BULLETIN 30435

MKII ALTERNATOR WITH GE0047-X REGULATOR

BULLETIN PJB MkII Alternator fitted with GE00047-X Regulator

Fig 1 Regulator Board Circuit Diagram M28800.

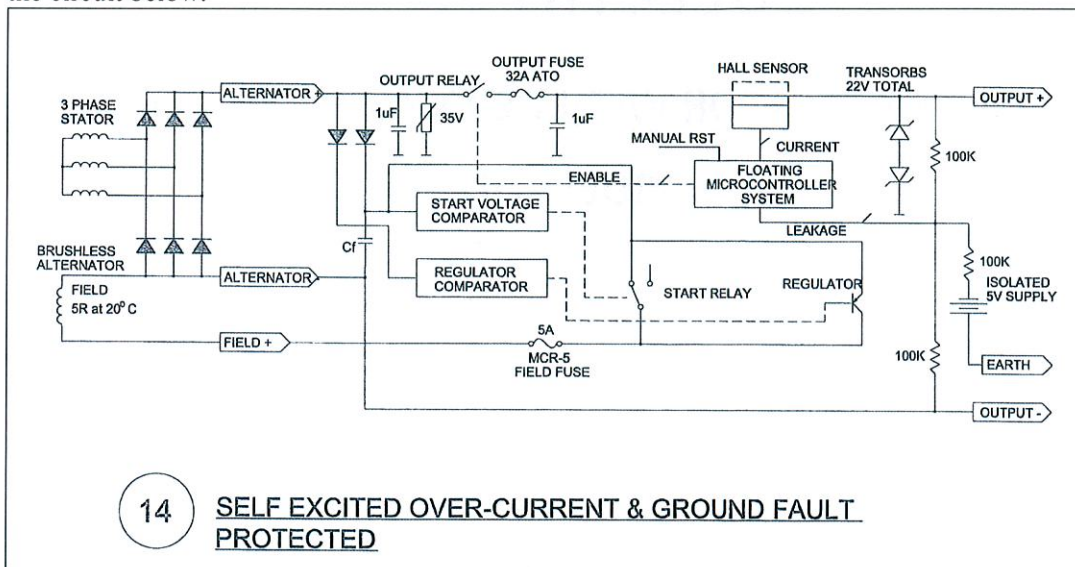
As a result of testing of the GE00047-X Regulator for the MkII Alternator it is evident that fault protection only disconnects the positive output from the alternator. The negative output is still powered when a trip is detected which leaves 3.8V in relation to earth. This may cause a spark if the cable has been cut and the negative wire comes in contact with chassis earth.

The explosion protected Alternator compliance is issued by Certificate of Conformity ANZEx 09.3007X or AUS Ex 2012(imperial unit). The regulator circuit is shown as a block representation on the Certificate of Conformity drawing M28800 sheet 2 Issue 07. Refer to the circuit below.

The operation of the protection does not comply with AS/NZS 4871.6:2013 Clause 6.2.3 which states that “All sources of supply shall be disconnected by the protection system”.

Fig 2 Additional Relay Circuit (kit 7-083280-700)

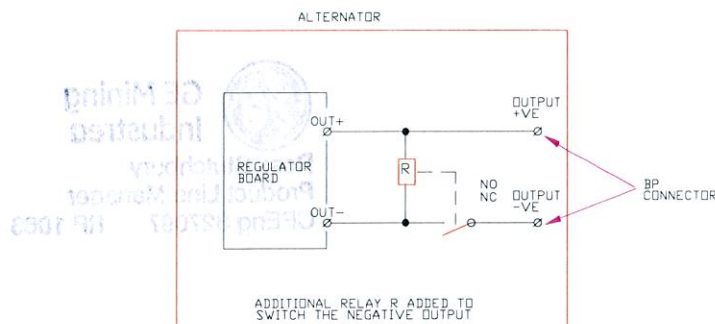
A relay module can be fitted to the alternator which will open the negative output from the alternator. Refer to the sketch below.

GE Industrea has developed a corrective measure to bring the PJB Alternator to compliance with the 4871.6 standard by including a second relay. On fault the relay protection will switch both positive and negative output of the alternator.

The necessary components can be easily fitted to the existing regulator board. On-site installation can be undertaken by a competent electrician, or if required the alternators can be returned to a GE Industrea workshop. Please refer to GE Industrea Work Instruction C-ExW15 for installation.
